MEMORANDUM

TO: ISC team
FROM: Daniel Sigg, Koji Arai
SUBJECT: EOM/AOM Diver Modifications
Refer to: LIGO-E1500353-v1

This modifications apply to [D0900761-B](#), [D0900847-B](#), [D0900848-C](#) and [D1000216-B](#) to bring them to revisions C, C, D and C, respectively.

Power Board [D0900848-C](#)

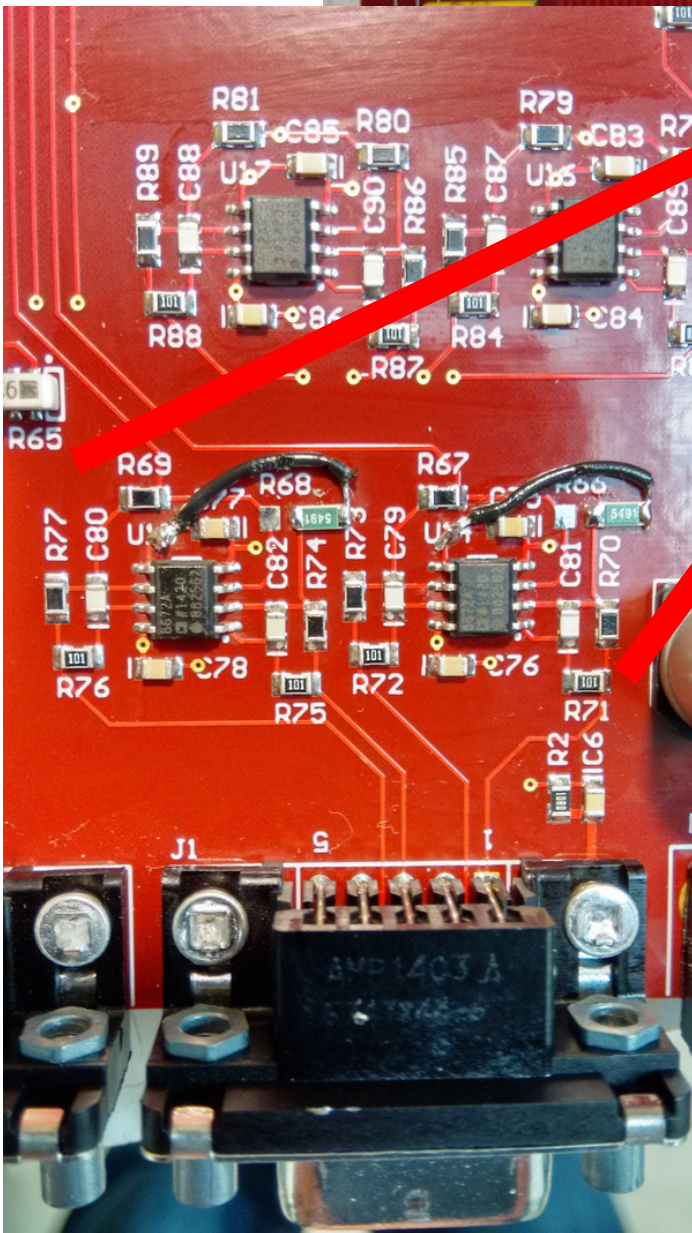
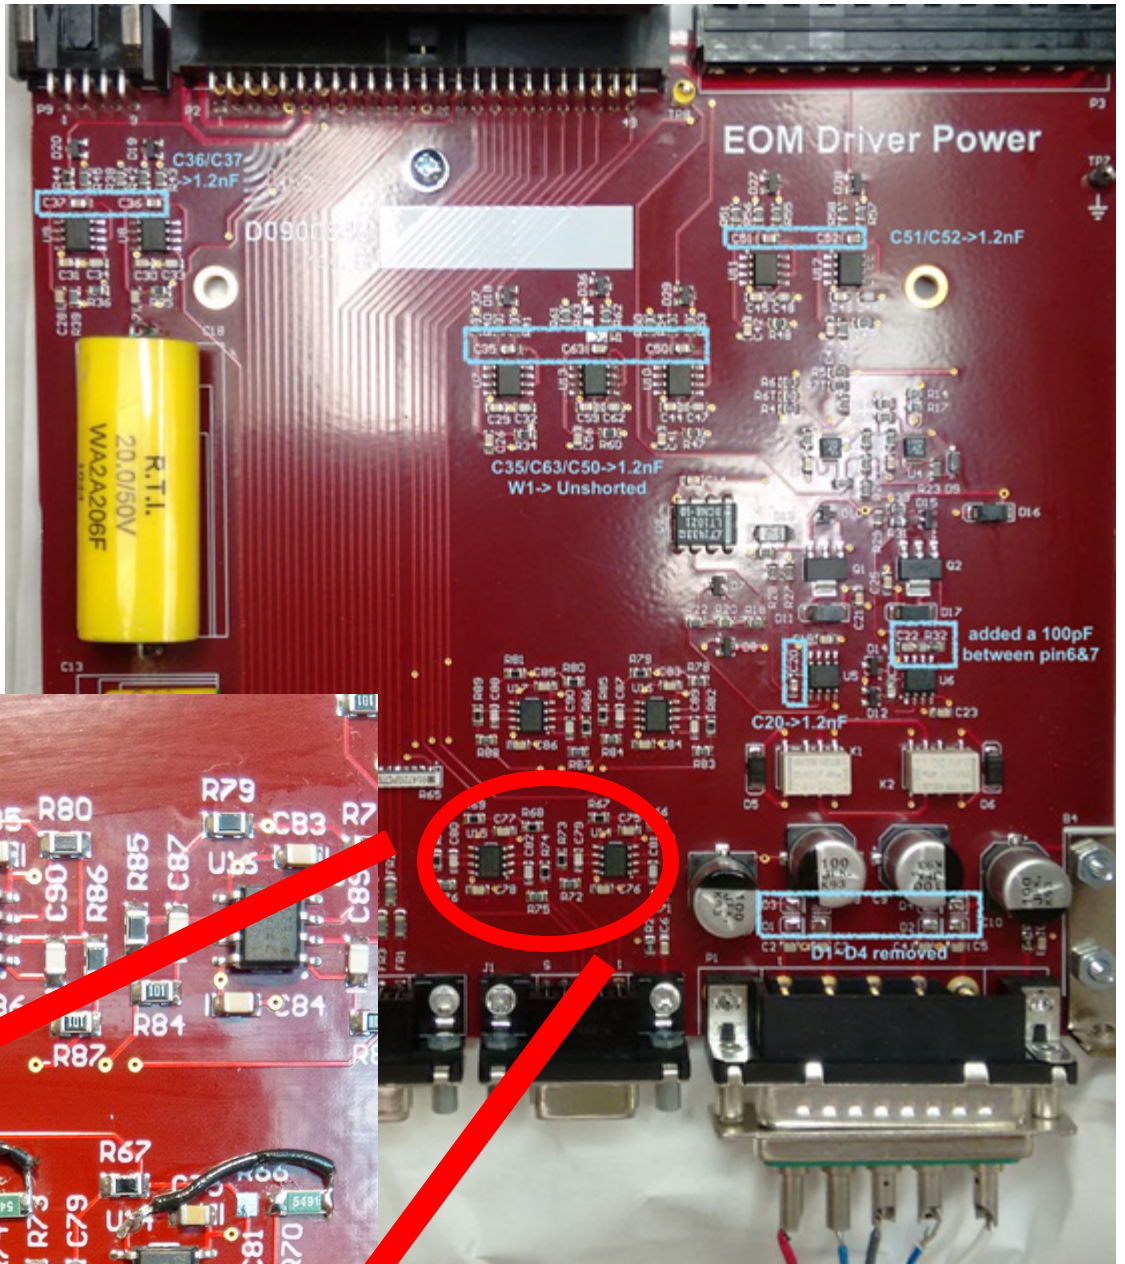
Fix the gain in the differential output stages.

R66, R68 → 5.49K, shift and use only the pad above R70 and R74

J1, J2 → add a jumper wire from the free end to ground (see pic)
